[Docket No. FAA-2013-0146; Directorate Identifier 2012-SW-060-AD; Amendment 39-17559; AD 2013-16-21]

#### **Airworthiness Directives; Agusta S.p.A. (Type Certificate Currently Held by Agusta Westland S.p.A) (Agusta) Helicopters**

**ACTION:** Final rule.

Figure 1 to Paragraph (f)(1), T/R Blade, P/N 109-8132-01-111

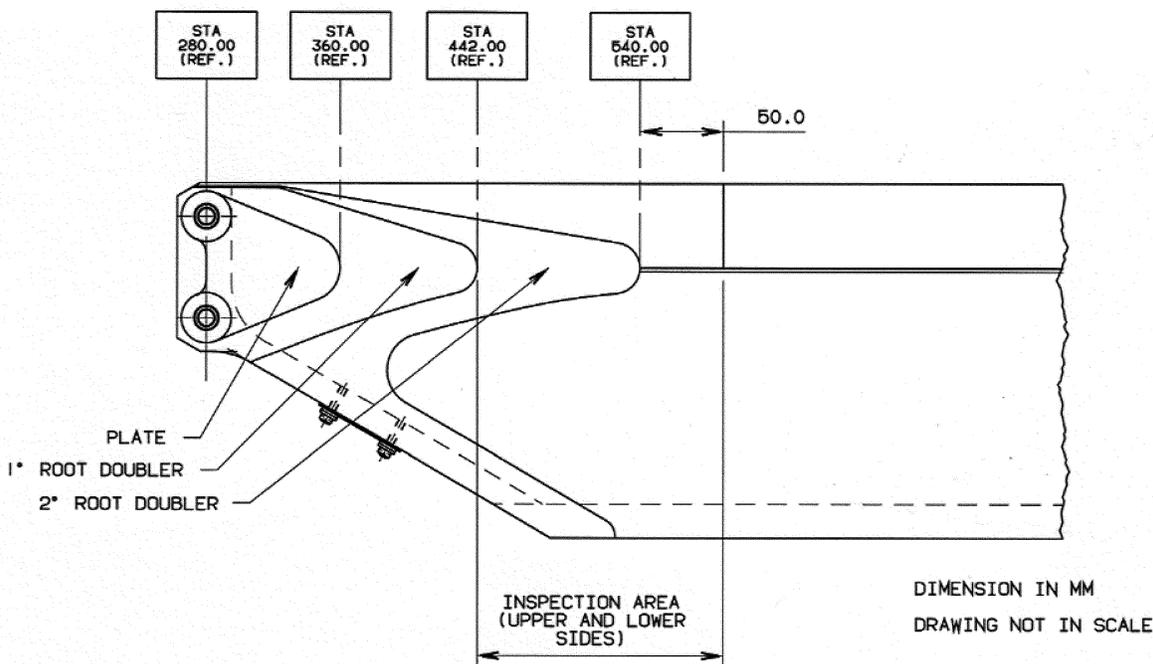
(1) Before each start of the helicopter engines, visually check both sides of each T/R blade for a crack in the inspection area depicted in Figure 1 to paragraph (f)(1) of this AD. This action may be performed by the owner/operator (pilot) holding at least a private pilot certificate, and must be entered into the aircraft records showing compliance with this AD in accordance with 14 CFR 43.9 (a)(1)-(4) and 14 CFR 91.417(a)(2)(v). The record must be maintained as required by 14 CFR 91.417, 121.380, or 135.439.
